Amendments to the Drawings:

REMARKS

FIG. 3

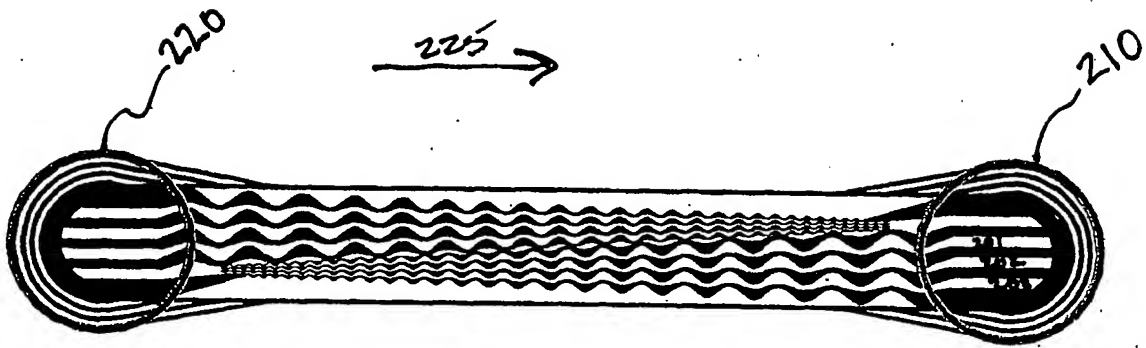
The Examiner objected to the drawings as including reference characters "15" in Fig. 1 and "200" in Fig. 3 not mentioned in the description. Applicants have included amended Figures 1 and 3 with these reference characters removed.

~~200~~
delete

The attached sheets of annotated drawings include changes to Figs. 1 and 3. The replacement sheets, which include Figs. 1-4(d), replace the original sheets. In Fig. 1, "15" has been removed; in Fig. 3, "200" has been removed.
